Rich Miller
Systems engineering

Re: Permissive change of STRATA TXU, TCU FCC ID. #
FC3STATXU2D

**CHANNEL A1r SPECTRAL MASK CFR 47 PART
74 (a)**

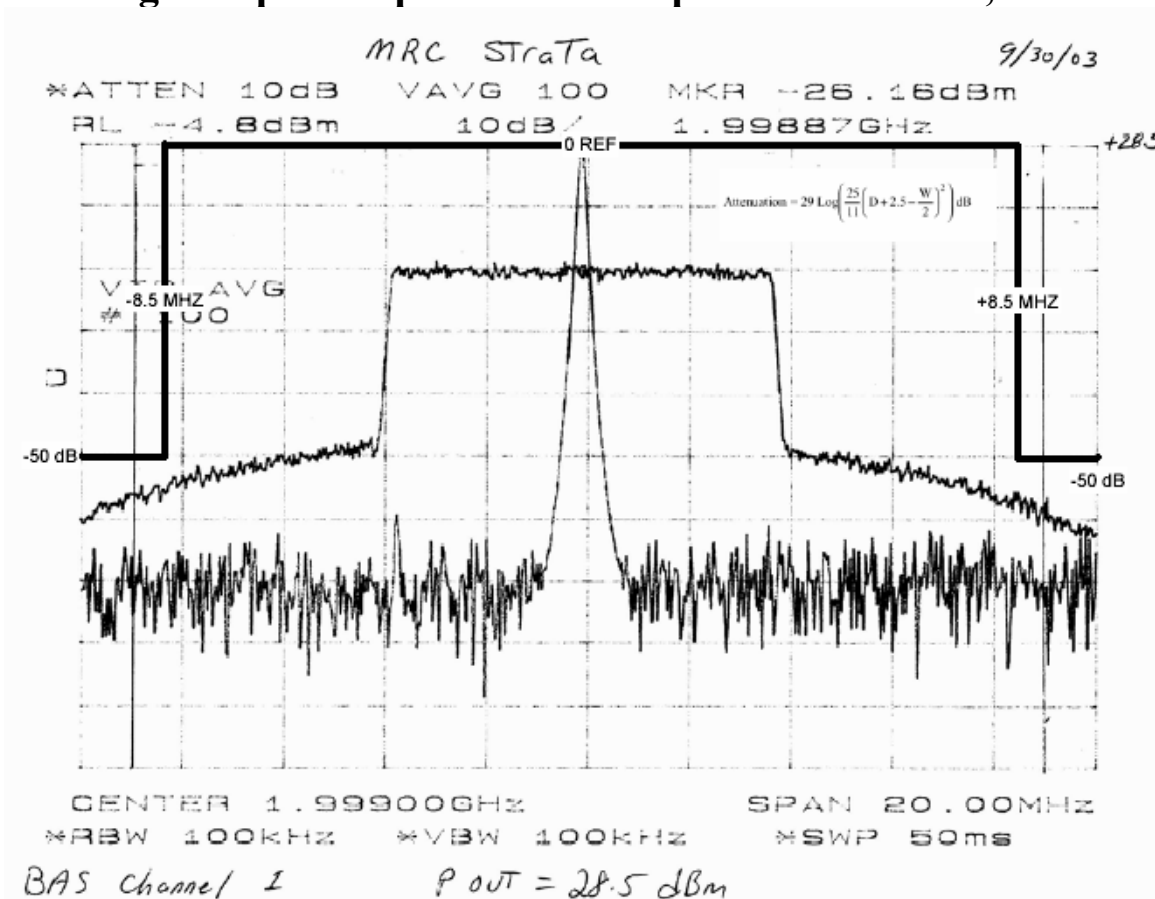
1. The Strata radio without any back off is barely able to give 1.5dbm on any channel in the digital mode. The product spec and review of the test data lists the digital output at one watt. The two watt max power detailed in the FCC cert in digital mode requires a HPU
2. An HPU is not included in the scope of the FCC cert. or the original TCF.
3. The original spectral plots show compliance at 28dbm,.6watts

PLOT COPIED FROM THE ORIGINAL TCF SHOWING COMPLIANCE AT 28dbm
50% REMOVED FROM CENTER FOR 17MHz CHANNEL MAS

**THIS PLOT WAS COPIED FROM THE PERMISSIVE
CHANGE DATA I PROVIDED FOR THE 12 MHz BAS
CHANNEL BANDWIDTH SHOWING COMPLIANCE
AT 28DBM**

***2033.5MHz .6 WATTS 28dbm QPSK 8 MHz FEC1/2 GUARD
INTERVAL 1/8 10dbm attenuator 1dbm cable loss***
